STAFF REPORT

Community Planning and Preservation Commission Certificate of Appropriateness Request

| Case No.: | 21-90200098 |
| Request: | Review of a Certificate of Appropriateness for the addition of a covered rear porch and other alterations at 2945 7th Ave. N., a contributing property to a local historic district. |

Figure 3: Survey showing proposed locations of fence, doors, and patio, from application

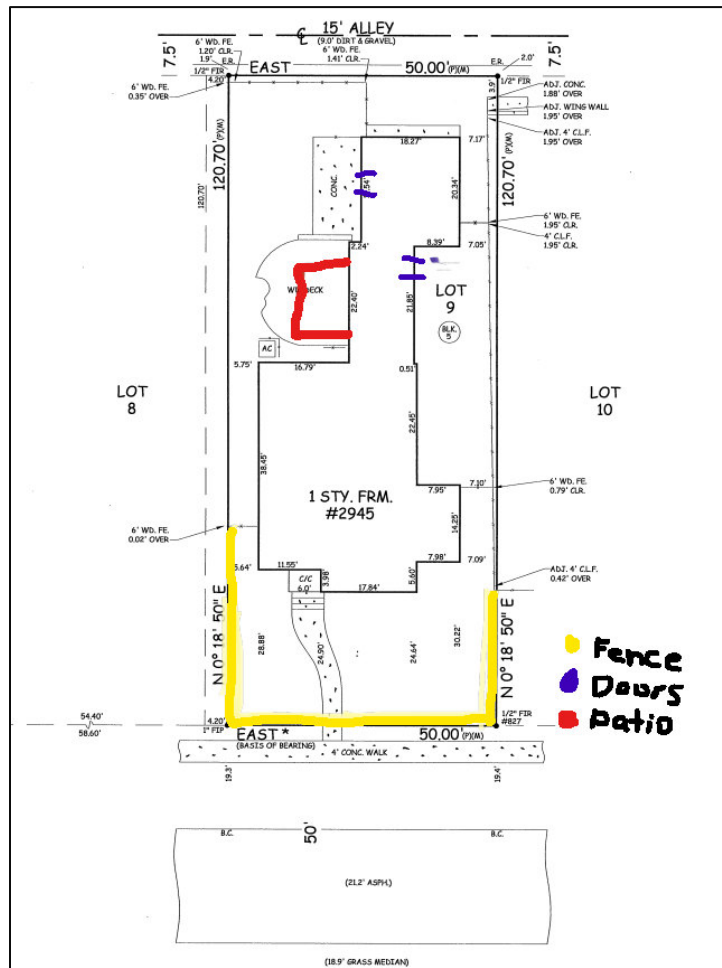
Consistent The proposed project locates major changes to the interior rear yard, minimizing the impact to the district.

Consistent The proposed openings are well-sited within the existing building.
The fabric screens will allow historic windows to remain in place.
The proposed porch will minimally affect the residence's design.

Consistent The proposed porch will be one story and will be visually compatible with the structure.

Consistent The proposed porch will be located on an existing deck and in an interior rear yard.

Inconsistent The application proposes an aluminum structure, which is not a traditional construction method.

Generally consistent The proposed roof will be nearly flat with a slight slope. Shed, gabled, or hipped roofs were more commonly constructed during the historic era, but flatter roofs were sometimes used, particularly for mid-century additions.

Based on a determination of general consistency with Chapter 16, City Code of Ordinances, staff recommends that the Community Planning and Preservation Commission **approve** the Certificate of Appropriateness request for the alteration of the property at 2945 7th Ave NE, a contributing property to the Kenwood Section – Northwest Kenwood Local Historic District, subject to the following:

Figure 9: Sample image of proposed front fence

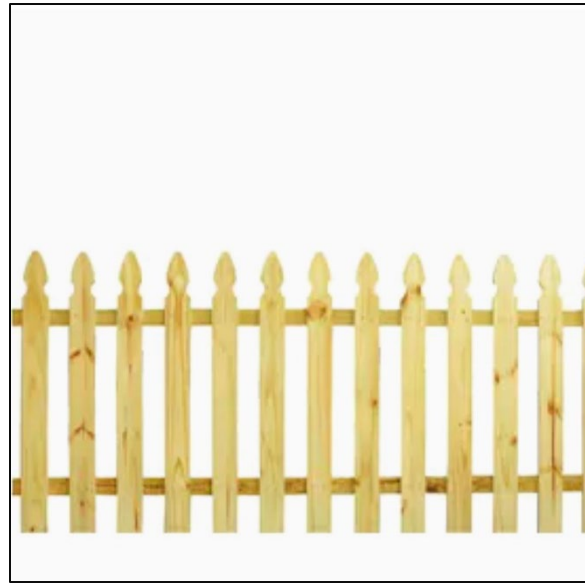
9. *Appurtenances of the new construction such as walls, gates and fences, vegetation and landscape features, shall, if necessary, form cohesive walls of enclosures along a street, to ensure visual compatibility of the new construction with contributing resources in the district.*

Consistent
